Access Compliance Report

Public Rights-of-Way (Curb Ramps)

Intersection ID: 28141	Main Street: PROVIDENCE_RD_WEST	Cross Street: OLD_ARDREY_KELL_RD	Location: NW
ADA ID: 3B90F7AC71CF	Ramp Type: BlendTrans1	Initial Pass/Fail: Pass	Overall Compliance: No
		Severity Score: 5

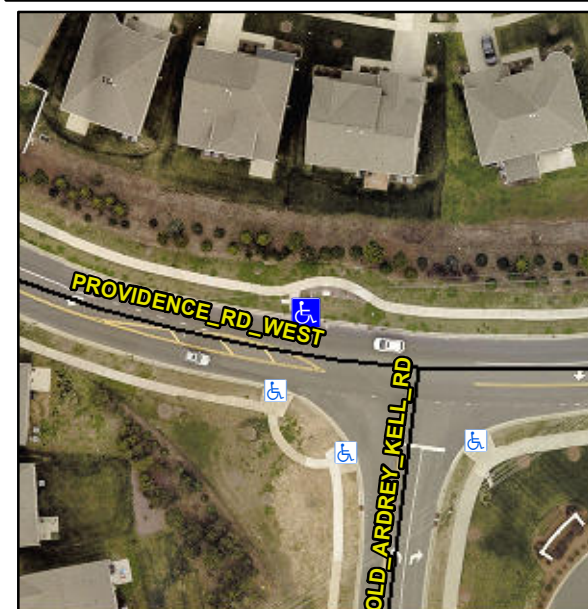
Not Found, R304.2.1, R304.5.4

Compliance	Description	Data	Compliance	Description	Data
N/A	Ramp Length (in)	56.0	Yes	BlendTrans Slope (%)	1.9
Yes	Ramp Width (in)	59.0	Yes	BlendTrans XSlope (%)	0.4
N/A	Flare Type LT	None	N/A	Flare Type RT	None
N/A	Flare Slope LT (%)	N/A	N/A	Flare Slope RT (%)	N/A
N/A	Flare Traversable LT?	N/A	N/A	Flare Traversable RT?	N/A
No	Landing Length (in)	43.0	Yes	DWS Provided?	Yes
Yes	Landing Width (in)	60.0	Yes	DWS Contrast?	Yes
Yes	Landing Slope (%)	1.0	Yes	DWS Length (in)	24.0
Yes	Landing X Slope (%)	0.7	Yes	DWS Full Width?	Yes
N/A	Landing Curb? (Y/N)	No	Yes	DWS Offset (in)	2.0
N/A	Shared Landing?	No			
Yes	Gutter Ponding?	No	No	Gutter Slope (%)	6.8
Yes	Gutter Lip Ht (in)	0.0	Yes	Gutter X Slope (%)	1.0
N/A	Painted X Walk1?	No	N/A	Painted X Walk2?	N/A
	X Walk 1 Direction	To S		X Walk 2 Direction	N/A
	X Walk 1 Width (in)	N/A		X Walk 2 Width (in)	N/A
	X Walk 1 Slope (%)	9.5		X Walk 2 Slope (%)	N/A
	X Walk 1 X Slope (%)	0.3		X Walk 2 X Slope (%)	N/A

N/A	Ramp inside XWalk1?	N/A	N/A	Ramp inside XWalk2?	N/A
	Road Slope (%)	0.3		Clear Space?	Yes
	Road X Slope (%)	9.5	N/A	Clear Space to XWalk (in)	N/A
Yes	Any Obstructions?	No	Yes	Storm Grate/Utility Hazard?	No
	Obstruction Type			Storm Grate/Utility Type	
		N/A			N/A
			Yes	Surface Condition? (G/P)	Good
			No	Curb Slope (%)	11.0

Remove & Replace Curb Ramp With Two New Directional Ramps or Equivalent. Remove & Replace Gutter.
